Office Action Summary	Application No. 10/579,312	Applicant(s) LIFKA ET AL.	
	Examiner JOSE M. DIAZ	Art Unit 2879

DETAILED ACTION

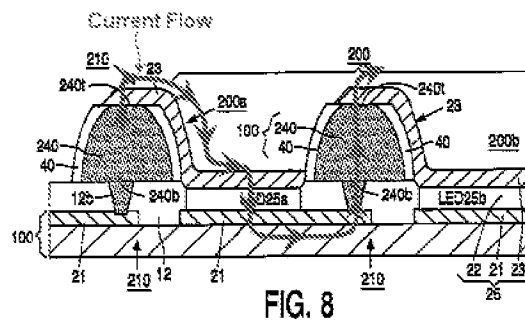
Regarding **claim 3**, Childs clearly shows and discloses that the barrier structures (240) of adjacent display pixels (200a & 200b) are in electrical contact (fig. 8, page 12, lines 11-13). As pointed out below the pixels 200a and 200b are connected in series. The current flows from the barrier 240 of the pixel 200a through the LED25a as a capacitive current reaching the barrier 240 of the pixel 200b.

Regarding **claim 6**, Childs clearly shows and discloses that the barrier structures (240) comprise side walls (SW, as pointed out bellow) having a substantially inclined orientation with respect to the substrate (100), the side walls (SW) being covered by an anodized insulating spacer layer (40) (fig. 17, page 15, lines 10-12).

FIG. 17

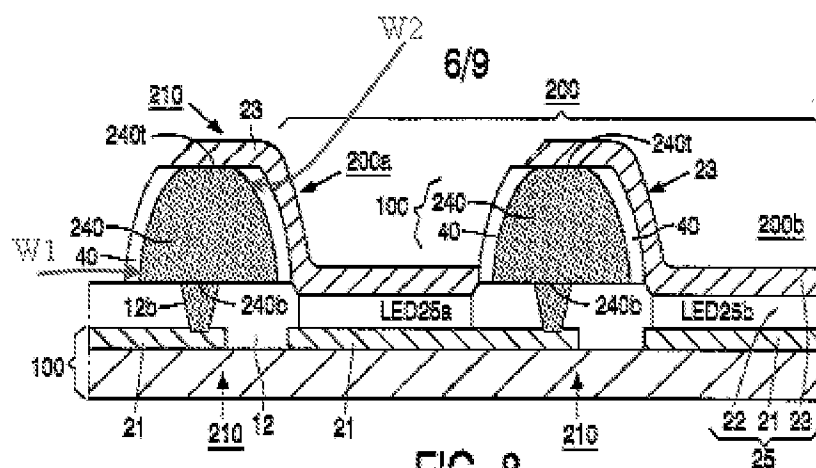
Regarding **claim 14**, Childs clearly shows and discloses the steps of: providing a mask layer (44) on or over the barrier structures (240); underetching the mask layer (44) to form substantially inclined side walls (SW, as pointed out on fig. 17 above) for the barrier structures (240); depositing an oxide insulating spacer layer (40) by executing an anodization treatment using a counter electrode and connecting the electrically conductive barrier structures (240) as a second electrode in an anodization bath (fig. 17, page 15, lines 9-24).

Regarding **claim 16**, Childs clearly shows and discloses that near edges of the display panel, a first width (W1, as pointed out by the examiner below) of said barrier structures (240) is larger than a second width (W2, as pointed out by the examiner below) of said barrier structures (240) at inner portions of the display panel (Fig. 8).

Regarding **claim 17**, Childs clearly shows and discloses that near edges of the display panel, a first width (W1, as pointed out by the examiner above) of said barrier structures (240) is larger than a second width (W2, as pointed out by the examiner above) of said barrier structures (240) at inner portions of the display panel (Fig. 8).
